## Addendum #3

<b>PROJECT:</b>	<b>ADDENDUM NO.</b>	003
<b>IVH Sheeler – Loftus Remodel</b>		
<b>Iowa Veterans Home</b>	<b>DATE ISSUED:</b>	11/28/2017
<b>1301 Summit Street, Marshalltown, IA 50158</b>	<b>BIDS DUE:</b>	12/06/2017 (Revised Date)
<b>DAS # 8950.00</b>

### TSP PROJECT NUMBER: 06-170221.00

A1 FIRST LEVEL LOGISTICS PLAN / LOCALIZED SITE  
SCALE: 1/16" = 1'-0"

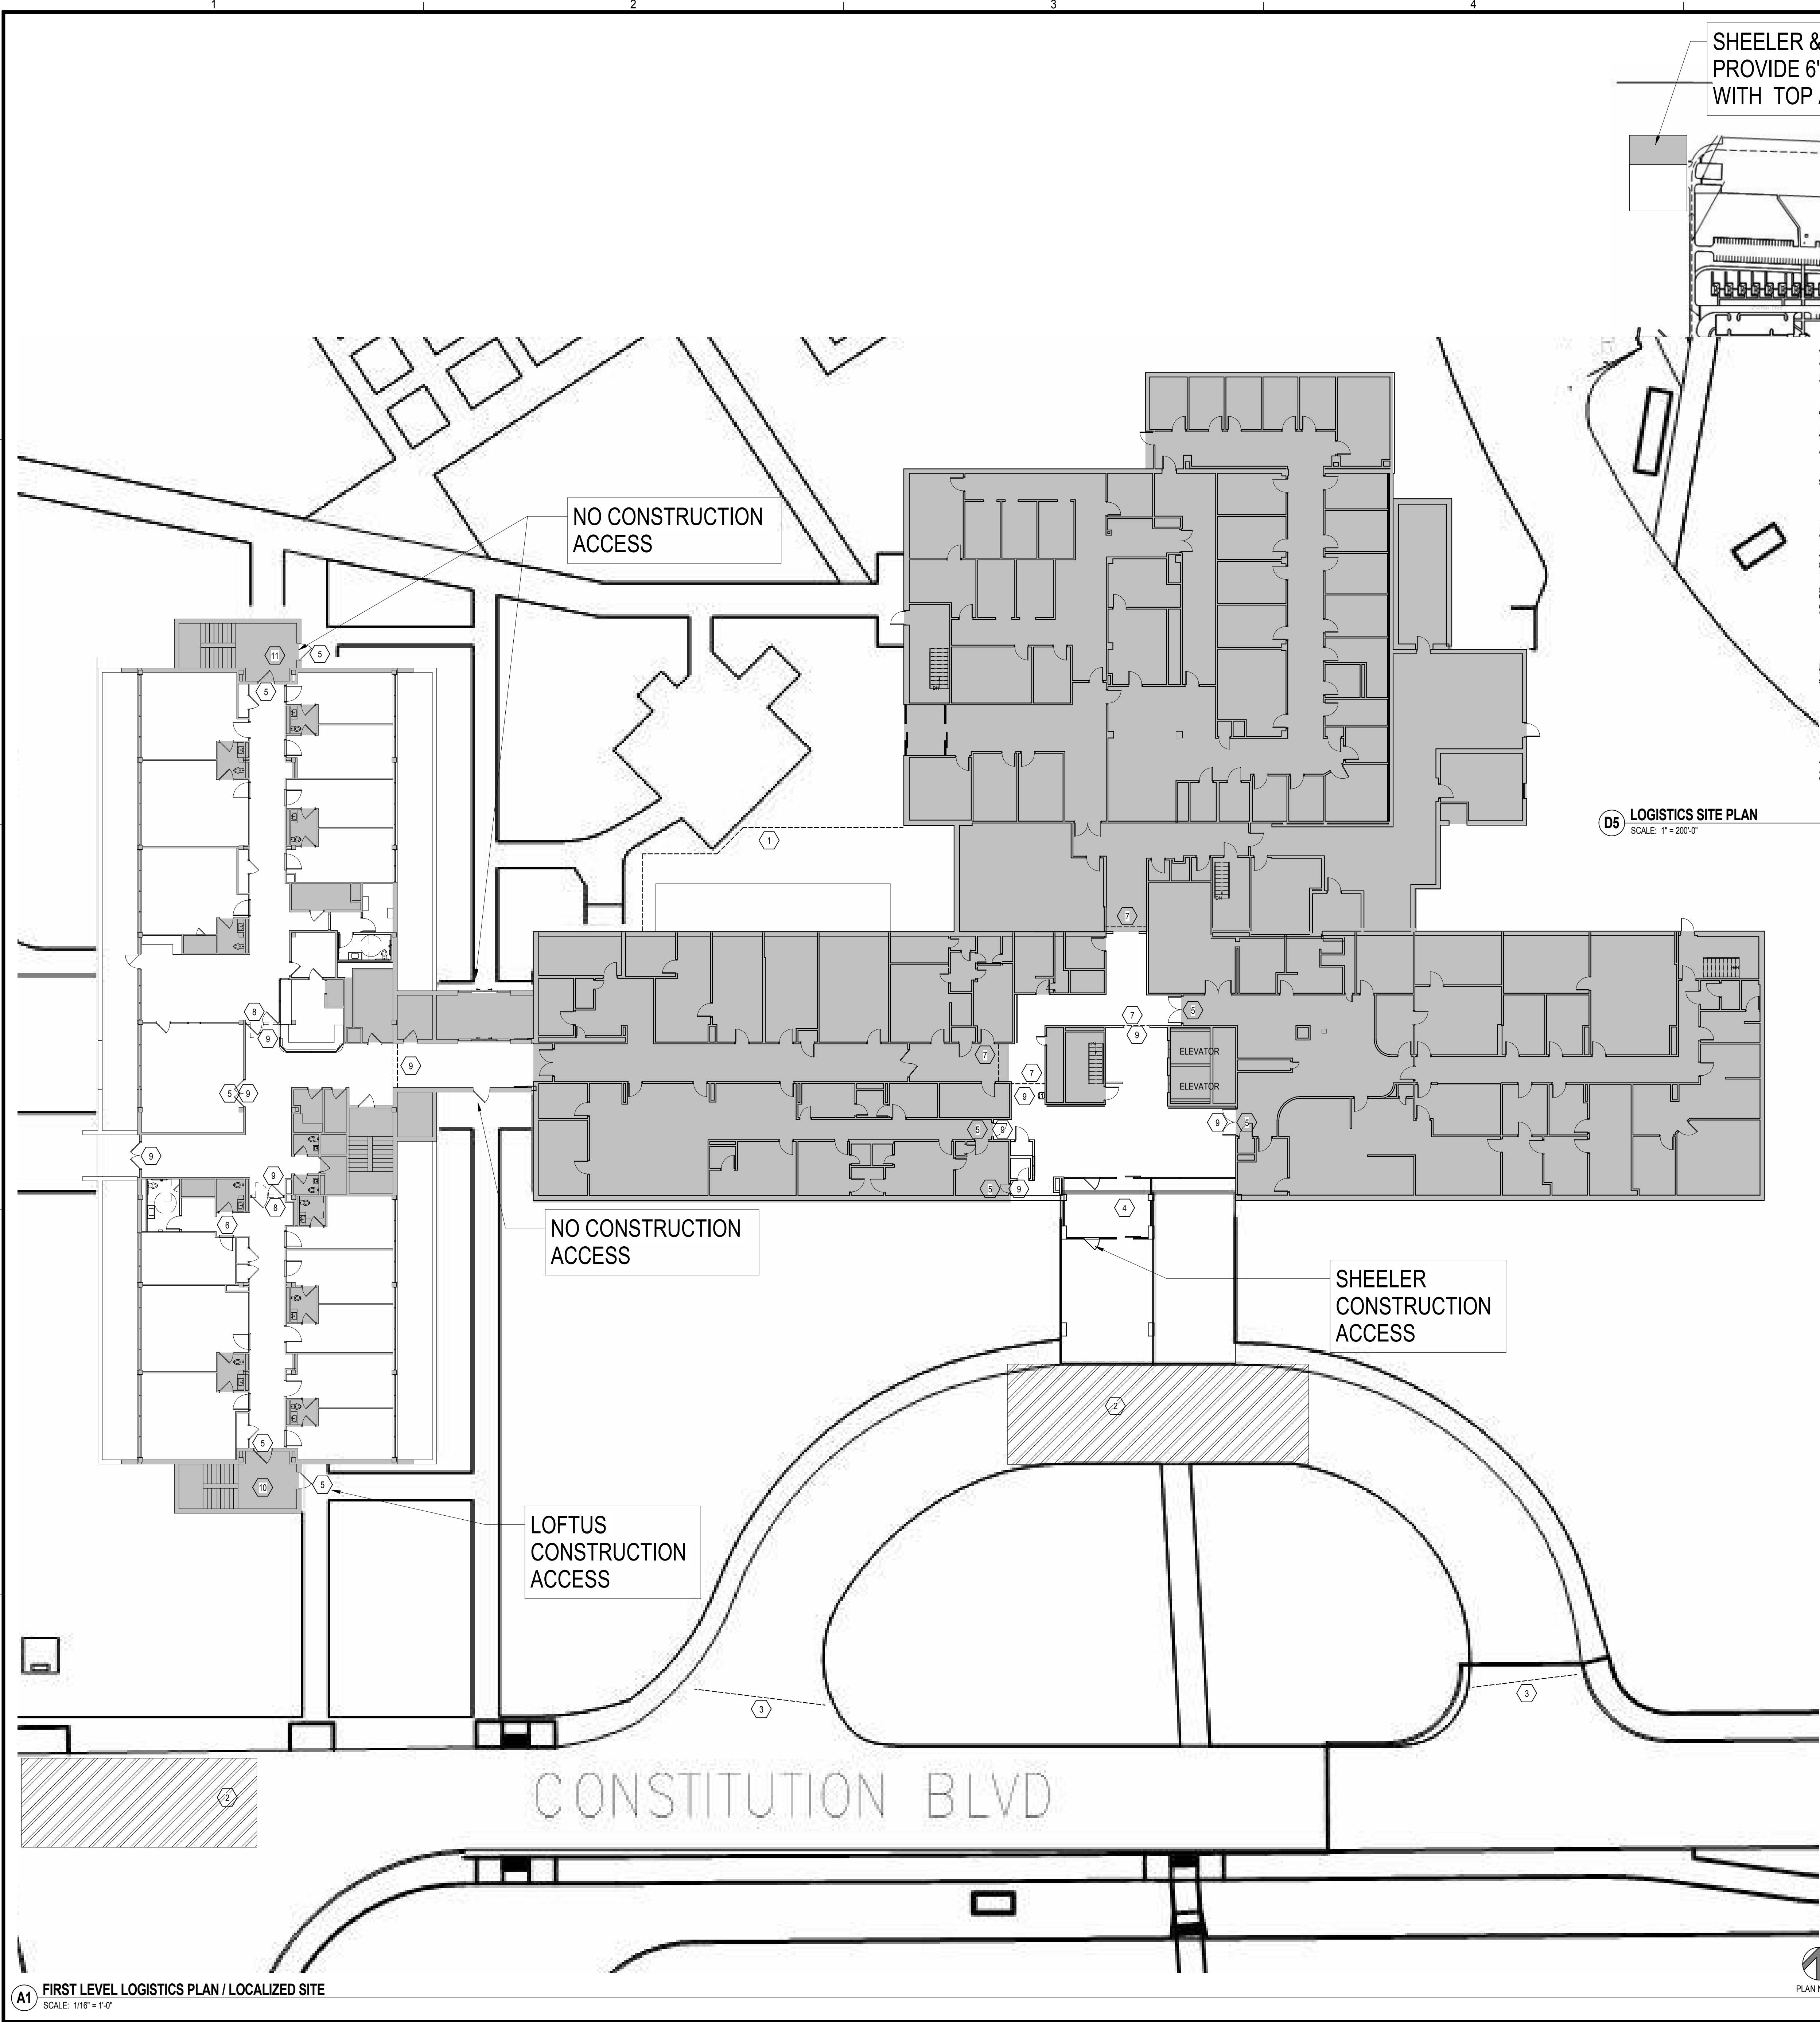
- a. **Reference:** Document 00 41 16 – Bid Form, Section 01 12 00 – Summary, Section 01 23 00 – Alternates, Addendum 01, Addendum 02, Drawings Sheet IN-101 Room Finish Plan and Schedule
- b. **Description:**
  - 1) Under Base Bid, Bid Package #2 shall protect existing VAT Resilient Tile Flooring at Main Floor Landing of Stair L112 from damage during construction.
  - 2) Under Alternate #3 Bid Package #1 “Abatement” shall remove existing VAT Resilient Tile and Adhesive at Main Floor Landing of Stair #L112.
  - 3) Under Alternate #3 Bid Package #4 “Finishes” shall provide and install new ‘CPT2” Carpet Tile at Main Floor Landing of Stair #L112.

- a. **Reference:** Document 00 41 16 – Bid Form, Section 01 12 00 – Summary, Section 01 23 00 – Alternates, Addendum 01, Addendum 02, Drawings Sheet IN-101 Room Finish Plan and Schedule
- b. **Description:**
  - 1) Under Base Bid, Bid Package #2 shall protect existing VAT Resilient Tile Flooring at Main Floor Landing of Stair L130 from damage during construction.
  - 2) Under Alternate #4 Bid Package #1 “Abatement” shall remove existing VAT Resilient Tile and Adhesive at Main Floor Landing of Stair #L130.
  - 3) Under Alternate #4 Bid Package #4 “Finishes” shall provide and install new ‘CPT2” Carpet Tile at Main Floor Landing of Stair #L130.

- a. **Reference:** Section 01 12 00 – Contract Summary, Attached Site Logistics Plan, Logistics Floor Plan and Localized Site Plan, Addendum 02
- b. **Description:** Bid Package #2 General Construction shall provide Sanitary Facilities, Dumpster and Orange Plastic Safety Perimeter Fence per attached Site Logistics Plan and Logistics Floor Plan and Localized Site Plan.

- a. **Reference:** Section 01 12 00 – Contract Summary, Attached Logistics Floor Plan and Localized Site Plan, Addendum 02
- b. **Description:** Bid Package 01 Abatement shall be responsible for air seals and other containment equipment as shown on the attached Logistics Floor Plan.

- a. **Reference:** Section 01 12 00 – Contract Summary, Attached Logistics Floor Plan and Localized Site Plan, Addendum 02
- b. **Description:** Bid Package #2 “General Construction” shall be responsible to erect, maintain and remove floor and wall protection, temporary walls and temporary doors as required for the sequence of work in accordance with the attached Logistics Floor Plan as a minimum. Existing doors and hardware (minus cores) salvaged from demolition of Office L118 and Toilet L119B may be used as temporary doors.

- UNDER BID PACKAGE 2: PROVIDE 48" ORANGE SAFETY FENCING AROUND AREA WAY REROOF.
- UNDER BID PACKAGE 2: PROVIDE 48" ORANGE SAFETY FENCING AROUND STAGING AREA AND PROVIDE DUMPSTERS AND KYBOS / TEMPORARY RESTROOMS.

- UNDER BID PACKAGE 2: PROVIDE TRAFFIC CONTROL CONES OR BARRICADES AT EACH END OF DROP OFF LOOP.
- UNDER BID PACKAGE 2: PROTECT EXISTING FLOORING FROM DAMAGE DURING ADJACENT CONSTRUCTION.

- UNDER BID PACKAGE 2: PROTECT EXISTING DOOR FROM DAMAGE DURING ADJACENT CONSTRUCTION.
- UNDER BID PACKAGE 2: SALVAGE THESE DOORS FOR USE IN TEMPORARY WALLS.

- UNDER BID PACKAGE 2: CONSTRUCT TEMPORARY WALLS TO ISOLATE CONSTRUCTION AREA. WALLS SHALL BE METAL OR WOOD STUDS WITH OSB, PLYWOOD, OR GYPSUM BOARD EACH SIDE. CORRIDOR (OCCUPIED) SIDE SHALL BE PAINTED. COORDINATE WITH ALTERNATE 2 REGARDING WALL LOCATIONS.

- UNDER BID PACKAGE 2: REMOVE EXISTING DOUBLE DOORS & AND STORE FOR REINSTALLATION. CONSTRUCT TEMPORARY WALL IN THE OPENING AND INSTALL ONE OF THE SALVAGED DOORS. AFTER CONSTRUCTION IS COMPLETED REINSTALL DOUBLE DOORS.

- UNDER BID PACKAGE #1 ABATEMENT CONTRACTOR SHALL SEAL ALL PENETRATION DURING THE ABATEMENT PROCESS.
- UNDER BID PACKAGE 2: PROTECT EXISTING FLOORING FROM DAMAGE DURING ADJACENT CONSTRUCTION UNDER BASE BID.

- UNDER BASE BID, BID PACKAGE #2 SHALL PROTECT EXISTING VAT RESILIENT TILE FLOORING AT MAIN FLOOR LANDING OF STAIR #112 FROM DAMAGE DURING CONSTRUCTION.

- UNDER ALTERNATE #3 BID PACKAGE #1 "ABATEMENT" SHALL REMOVE EXISTING VAT RESILIENT TILE AND ADHESIVE AT MAIN FLOOR LANDING OF STAIR #112.
- UNDER ALTERNATE #3 BID PACKAGE #4 "FINISHES" SHALL PROVIDE AND INSTALL NEW "CPT2" CARPET TILE AT MAIN FLOOR LANDING OF STAIR #112.

- UNDER BID PACKAGE 2: PROTECT EXISTING FLOORING FROM DAMAGE DURING ADJACENT CONSTRUCTION UNDER BASE BID.
- UNDER BASE BID, BID PACKAGE #2 SHALL PROTECT EXISTING VAT RESILIENT TILE FLOORING AT MAIN FLOOR LANDING OF STAIR #130 FROM DAMAGE DURING CONSTRUCTION.

- UNDER ALTERNATE #4 BID PACKAGE #1 "ABATEMENT" SHALL REMOVE EXISTING VAT RESILIENT TILE AND ADHESIVE AT MAIN FLOOR LANDING OF STAIR #130.
- UNDER ALTERNATE #4 BID PACKAGE #4 "FINISHES" SHALL PROVIDE AND INSTALL NEW "CPT2" CARPET TILE AT MAIN FLOOR LANDING OF STAIR #130.
